COOPER NUCLEAR STATION

AMENDMENT TO FACILITY OPERATING LICENSE

Amendment No. 41
License No. DPR-46

SAFETY EVALUATION BY THE OFFICE OF NUCLEAR REACTOR REGULATION
SUPPORTING AMENDMENT NO. 41 TO FACILITY OPERATING LICENSE NO. DPR-46
NEBRASKA PUBLIC POWER DISTRICT
COOPER NUCLEAR STATION
DOCKET NO. 50-298

Figure 6.1.1
NPPD Management
Organization Chart

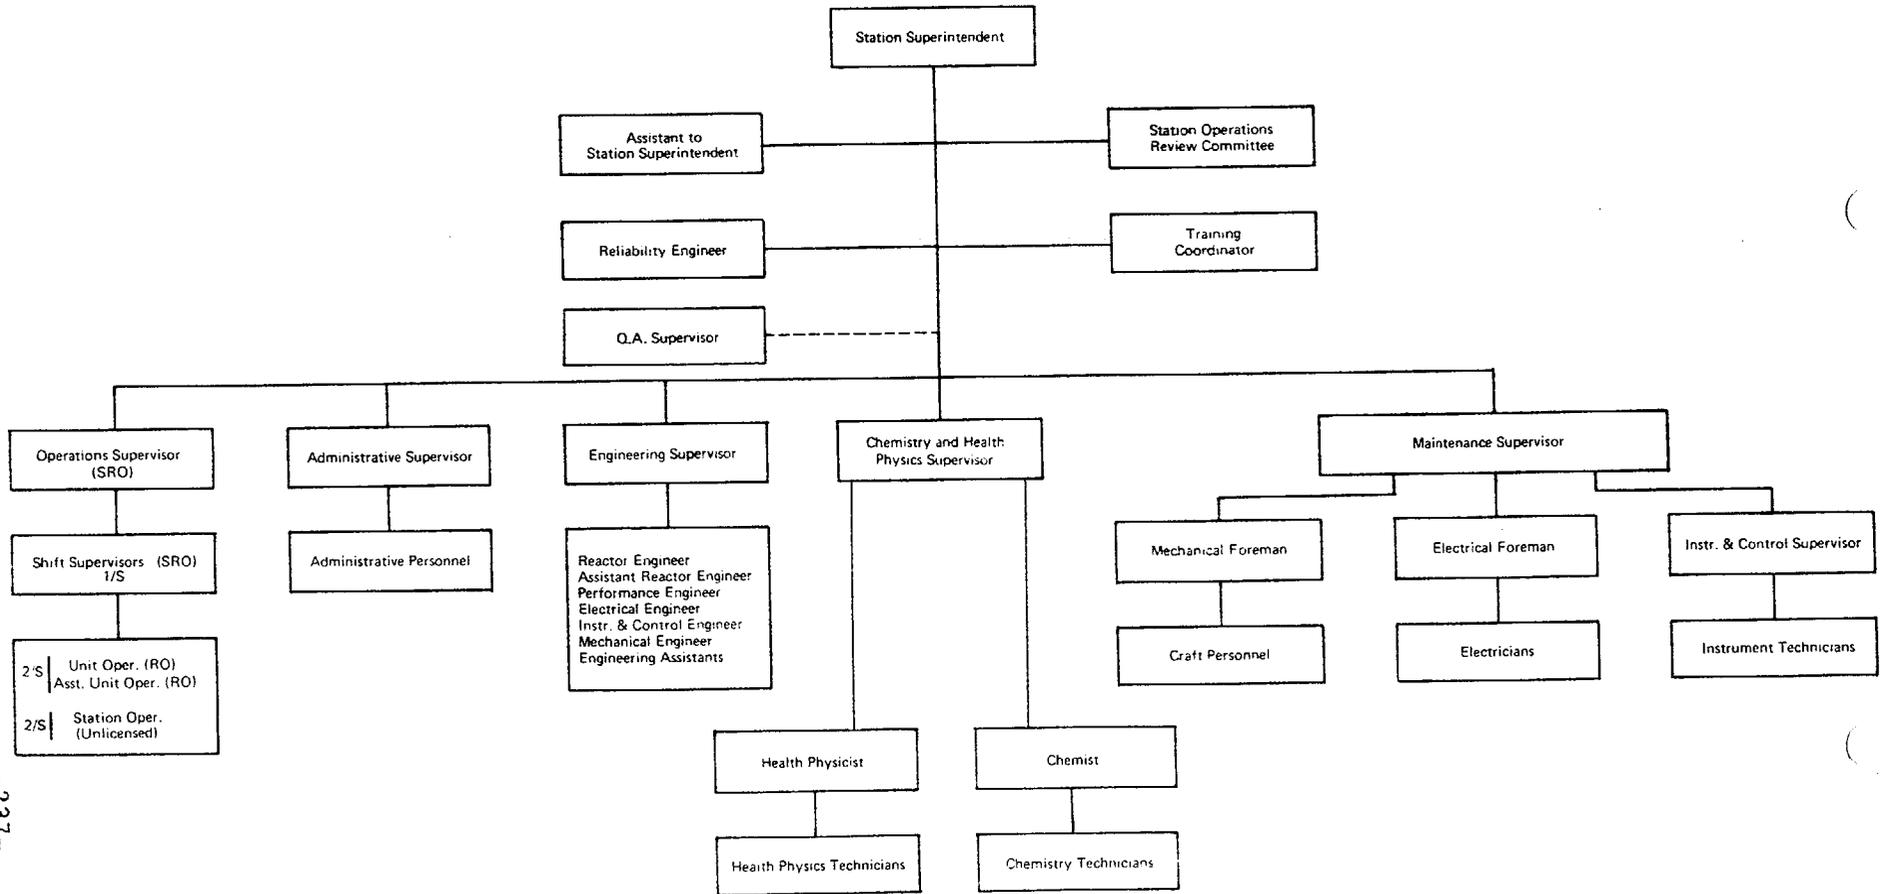
By letter dated December 23, 1977, NPPD submitted a revised organization chart for inclusion in the CNS Technical Specifications. The organizational changes were:

1. The title of "Director of Generation Engineering and Construction, to whom the CNS Station Superintendent reports, has been changed to "Director of Power Projects" and this position now reports directly to the office of the General Manager.
2. The Director of Power Supply has been designated as the responsible corporate individual for the Fire Protection Program at CNS.

We have evaluated these proposed changes and found them acceptable because the functions of the Director of Power Projects would remain essentially unchanged and the effectiveness of the CNS management chain should be improved by the direct link between the Director of Power Projects and the NPPD General Manager. Also, the designation of an individual in corporate management as responsible for the fire protection program at CNS fulfills a requirement deriving from the ongoing NRC fire protection review of nuclear plants.
